# THE-GREEN SOUTHALL

Design & Access Statement  
Addendum incorporating responses to  
DRP and other consultee comments  
Oct 2021

This document has been prepared as an Addendum to the submitted Design and Access Statement (April 2021).

# SLENDERNESS RATIO OF TOWERS REVIEW - TOWER C1

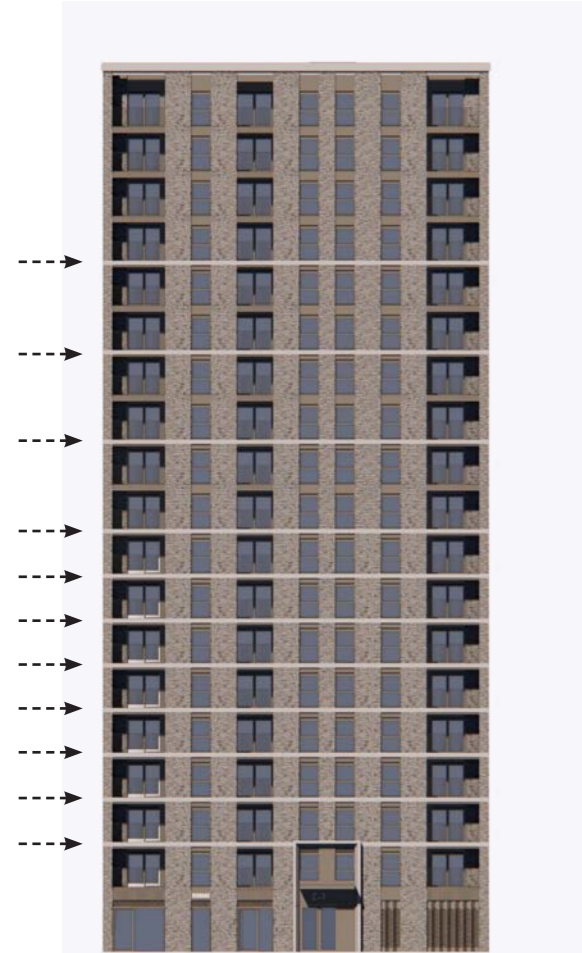
*DRP comments: “While the panel understands the approach to massing in terms of the block footprint, it feels that currently it results in rather bulky towers, especially at Block C.*

*By redistributing the massing, more slender and elegant elements would be possible, breaking up the visual impact of the scheme, especially as seen from Manor House Grounds.”*

We have increased the height between GRC bandings to visually elongate the perceived height of the building .

Using a slightly lighter shade of grey bricks on the facade also helps to reduce the visual weight of the building.

It is also worth noting that whilst the front elevation of Block C1 (where building entrance is located) has a lower slenderness ratio, as the standard floor plate has been designed to maximise the south facing aspect.

Figure 4: Assessment areas for SHOG (yellow depicts the areas receiving over 2 hours of sun on 21<sup>st</sup> March).

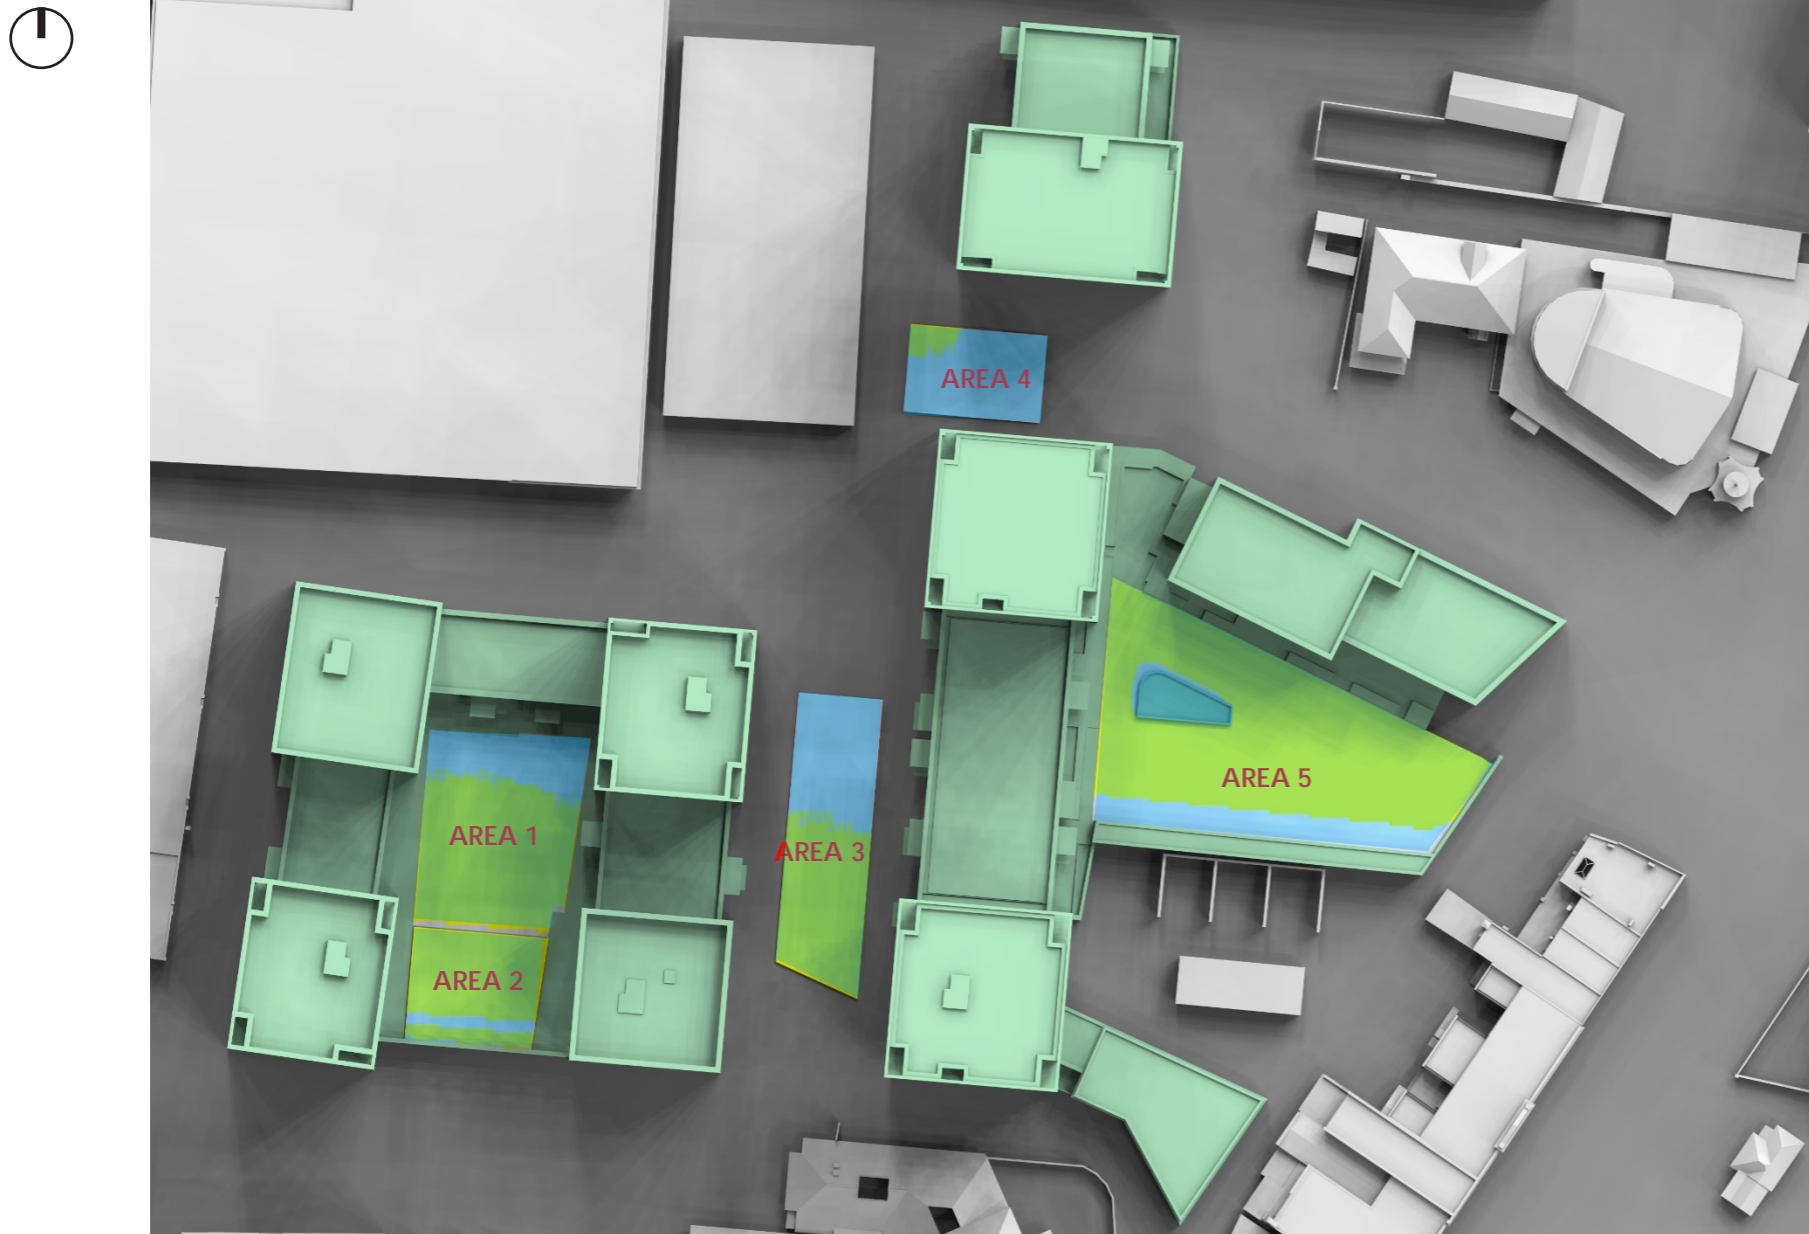
*DRP comments: "...overshadowing, which is still likely to be a significant issue. While the analysis of overshadowing and microclimate effects across the schemes public realm is welcome, the likely impacts on specific uses at specific times of the day (such as for the restaurants envisaged along the central boulevard or for play space) would be helpful."*

*GLA comments: "careful consideration of sunlight/daylight penetration is required to ensure that the increased height would not overshadow public realm areas for longer periods of time and would not impact on daylight amenity of the neighbouring properties."*

The amenity areas within the Proposed Development have been assessed in accordance with the BRE Guidelines SHOG assessment. The five areas are shown in Figure 4 below and the drawing numbered BRE/184 in Appendix 5. The proposed outdoor amenity areas have been grouped into 5 main areas.

Areas 1, 2, 3 and 5 receive a minimum of 2 hours of sun over 50% of the area on 21<sup>st</sup> March and therefore meet the BRE Guidelines recommendations. Area 4 is located to the north of the Proposed Development where lower levels of sunlight would be anticipated.

# SHADOW DIAGRAMS

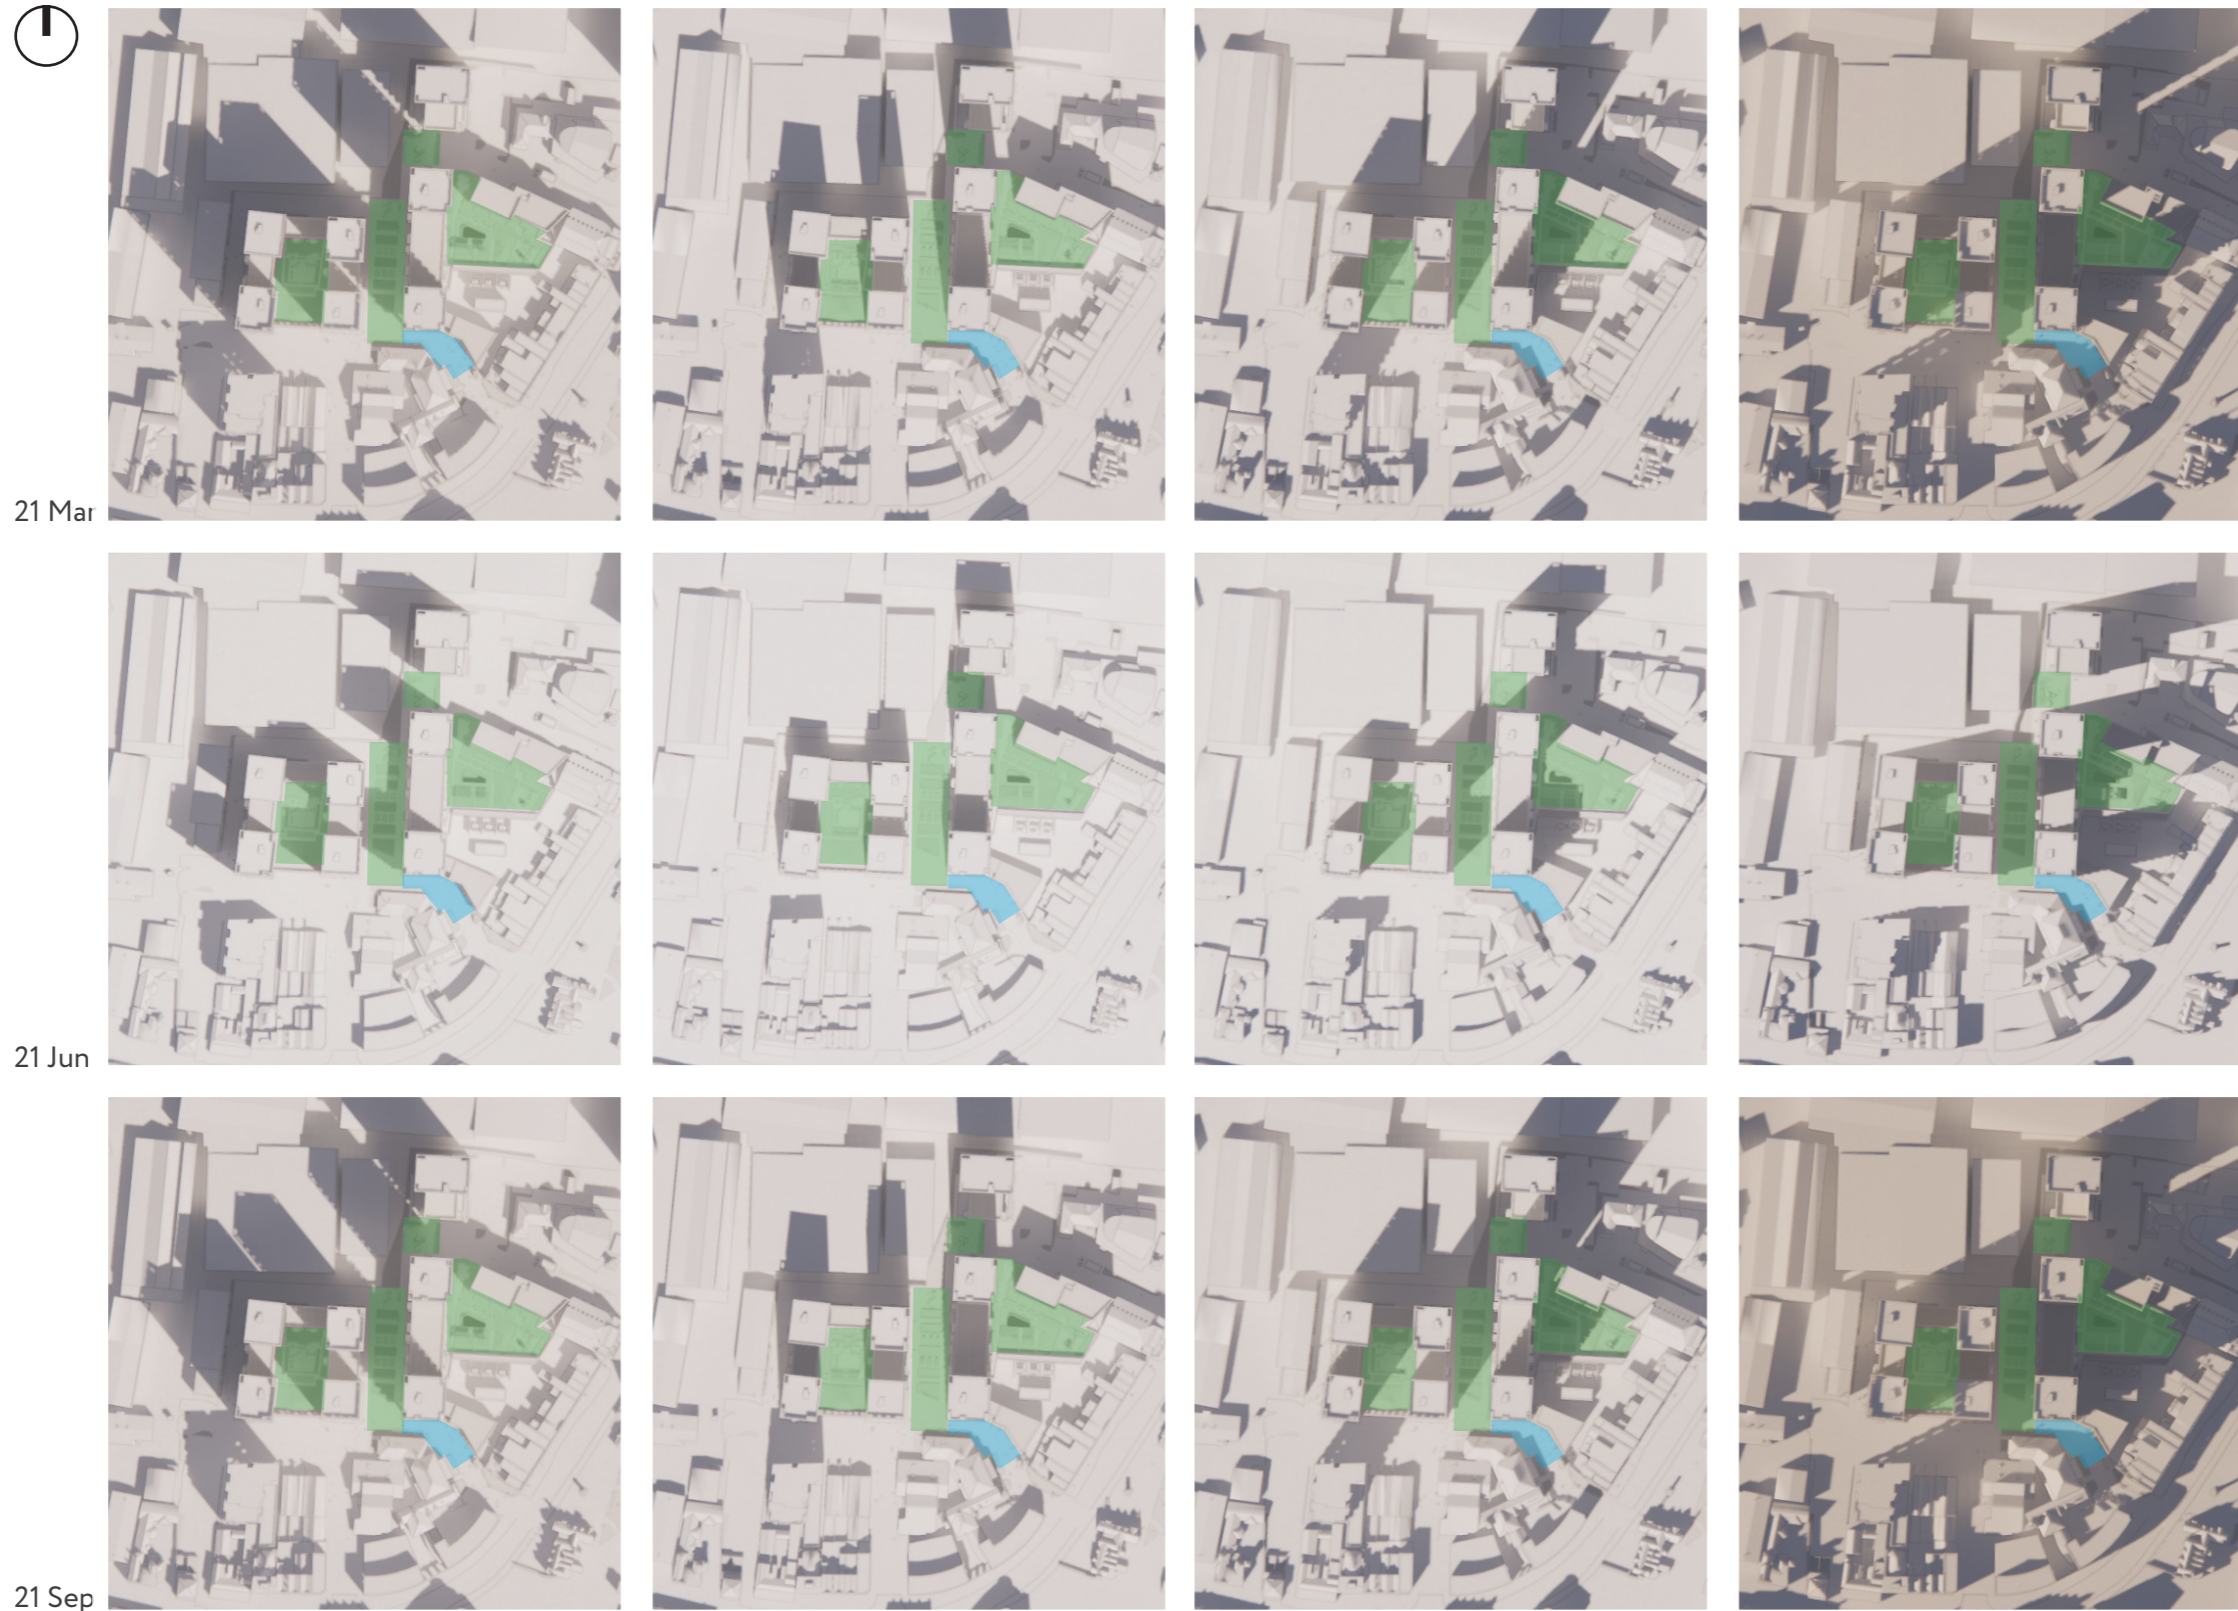
*... Building C1 could be shifted to north of the block to increase building separation from Block B2 and subsequently improve privacy and daylight/sunlight access."*

The following diagrams show a mirrored Block C (positioning the tall element away from Area 4), to see whether improvement can be made to the overshadowing of Area 4. As illustrated by the shadow diagrams below, this has little affect on the overshadowing of Area 4 as the overshadowing are mainly created by the tall buildings located to the south of Area 4.

Block C mirrored so that the gap between the main tower and adjacent Tower B2 is increased.

# MEWS TO BUILDING A2

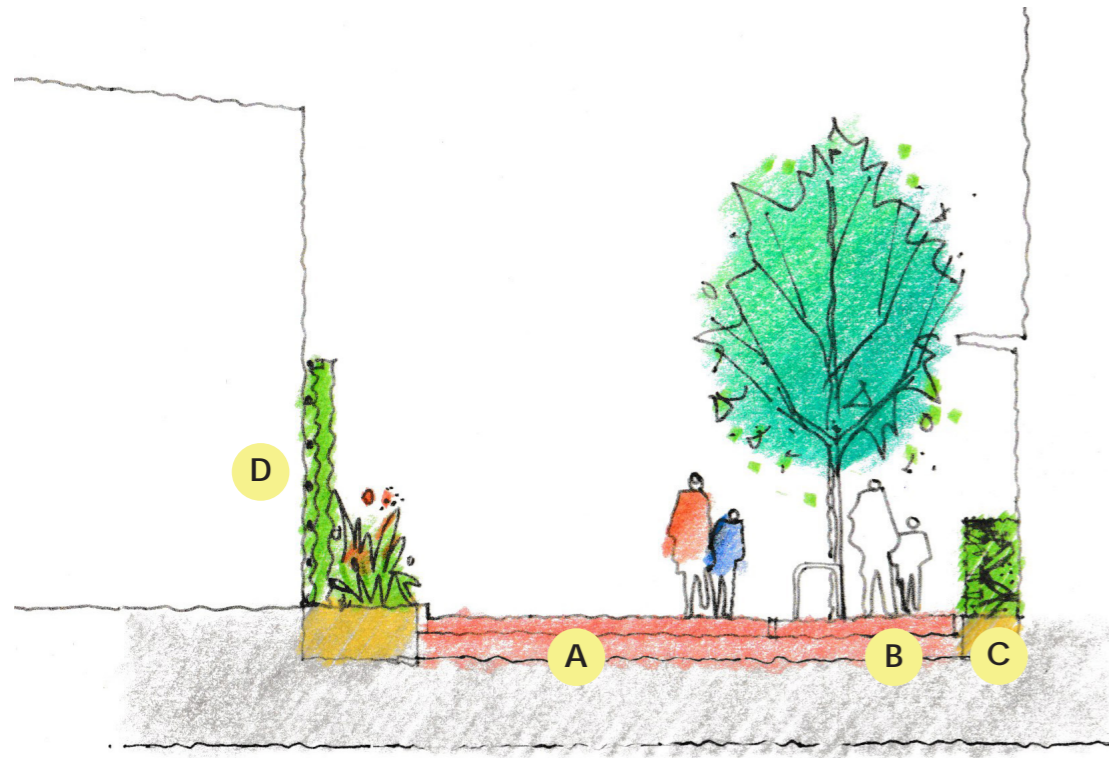
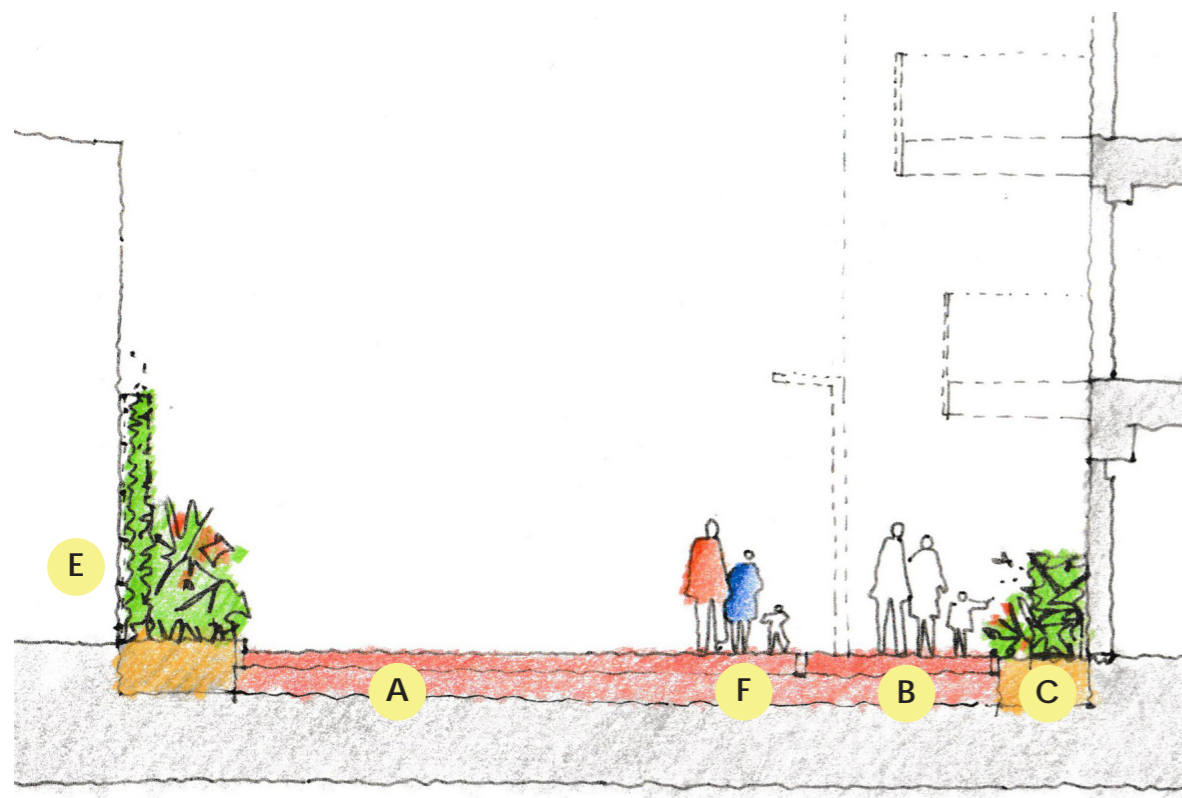
*DRP comments: “The panel has some concerns about the condition of the residential frontage to the industrial uses on the western boundary of the site. Greater clarity is needed about how this will be managed until the rest of the allocation is developed, as in the interim this could feel quite hostile and intimidating to residents here.”*

*GLA comments: “The complex geometry of the site has numerous side frontages, boundary conditions and adjoining owners. Further details of boundary treatment should be provided to understand necessary vehicular and pedestrian access points, and to ensure that boundary conditions are not perceived merely as back of house spaces. The proposals must be carefully detailed to ensure high quality public realm is achieved, in collaboration with adjoining landowners.*

- A** Mews access around Building A - varied width to allow passing & delivery parking - between 4m & 5.5m
- B** Comfort zone - material and level to match mews - generally 1.5m wide with flush channel between
- C** Defensible hedge - generally 750mm wide
- D** Climbers to adjacent building's facade by agreement with lower level planting
- E** Planted boundary - out with ownership including climbers attached to adjacent building - all by agreement
- F** Loading bay and passing place outside refuse store

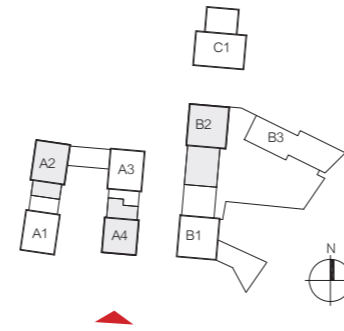
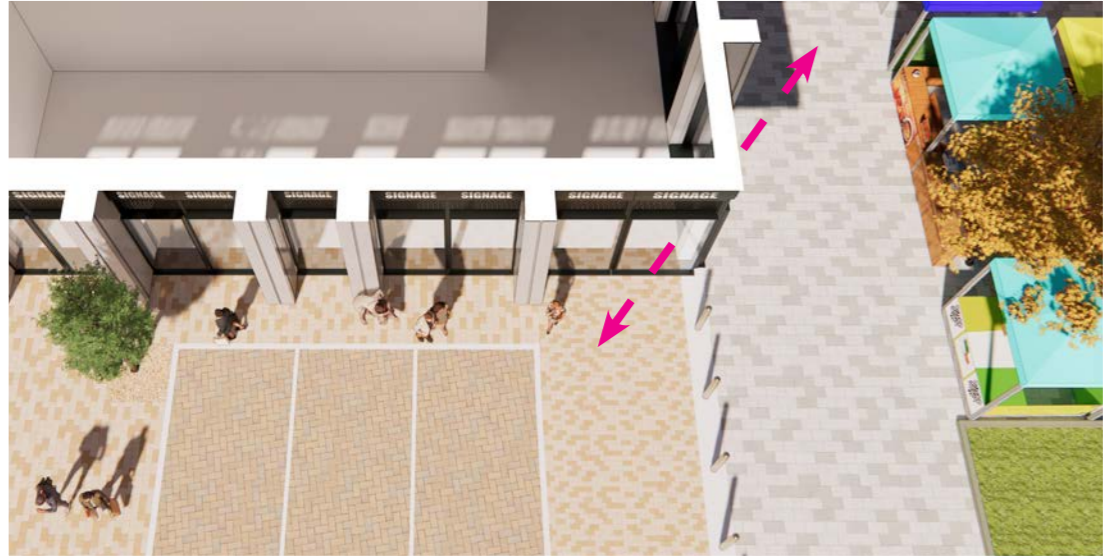
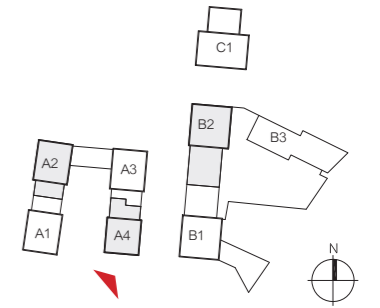
*DRP comments: “The panel feels that the building proposed for the end of Dominion Road (Block A4) functions as a barrier to the scheme, rather than as an invitation, and signals a termination to the public realm. Instead the panel suggests focusing on activation and landscape to draw visitors into the scheme.”*

- The ground floor elevations of Block A4 have been “opened up” with more glazing, allowing the commercial space to function as a gateway rather than a barrier to the scheme.
- GRC has been extended to clad the ground floor elevation of Block A4 to further complement the commercial use. Wrap-around canopy, coupled with a corner window help to enforce both physical and visual link into the ‘Central Heart’.

- Wrap-around canopy and higher ratio of glazing introduced to Block A4 Ground Floor to enliven the 'Dominion Approach';
- Corner window introduced to improve visual permeability and strengthen connection between the 'Central Heart' and 'Dominion Approach'
